Wisconsin Department of Transportation

Proposal #16: 1570-00-78, WISC 2026012
St Croix Falls – Turtle Lake
STH 35 N to STH 46 S
USH 8
Polk County

This is Addendum No. 01, which provides for the following:

ADDENDUM NO. 01

Addendum No. 01
ID 1570-00-78
Revised Sheet 4
October 2, 2025

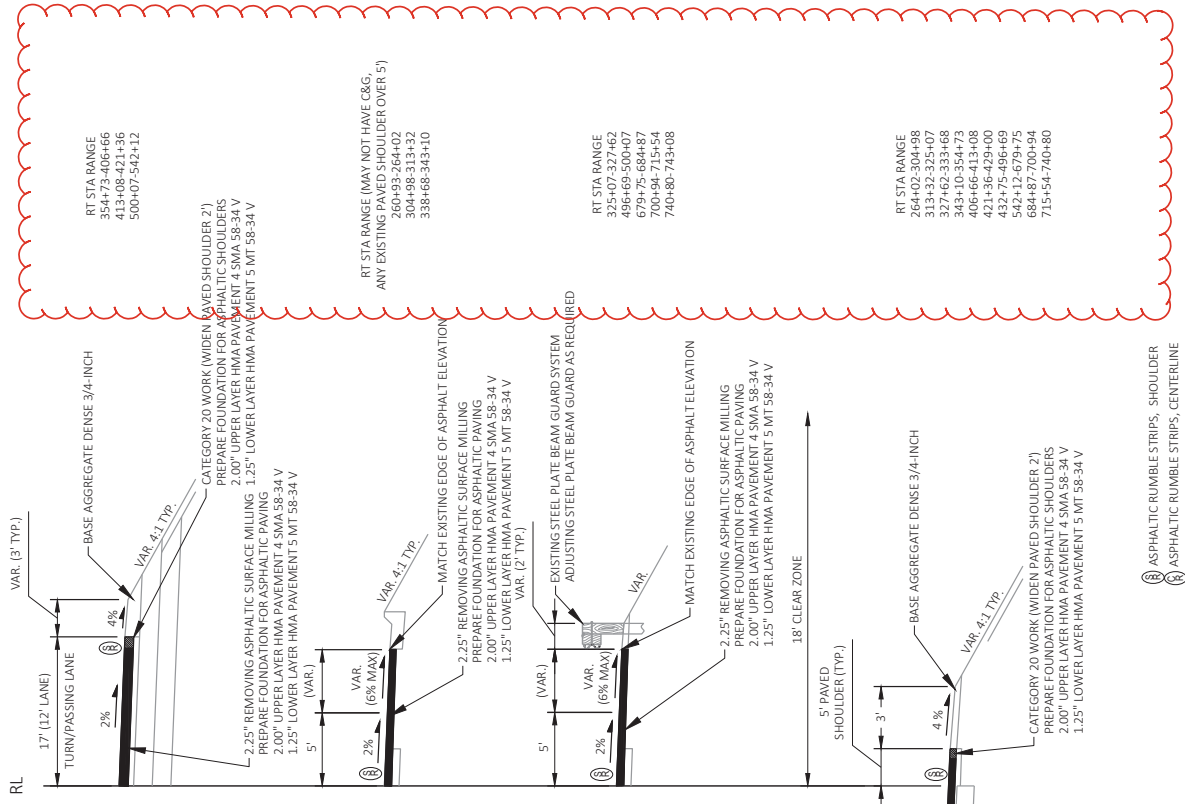
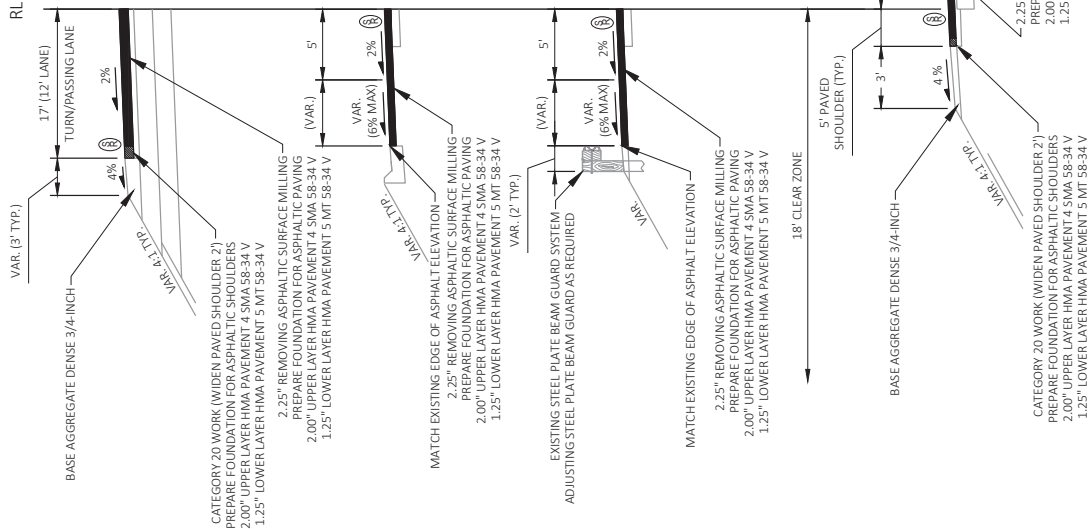
Revised Plan Sheets	
Plan Sheet	Plan Sheet Title (brief description of changes to sheet)
4	Updated station ranges
5	Updated HMA Mix types on both Typical
27	Added 204.0126.S table and removed item 460.0110.S from the table
28	Added a line to the table for the Sloughing Areas
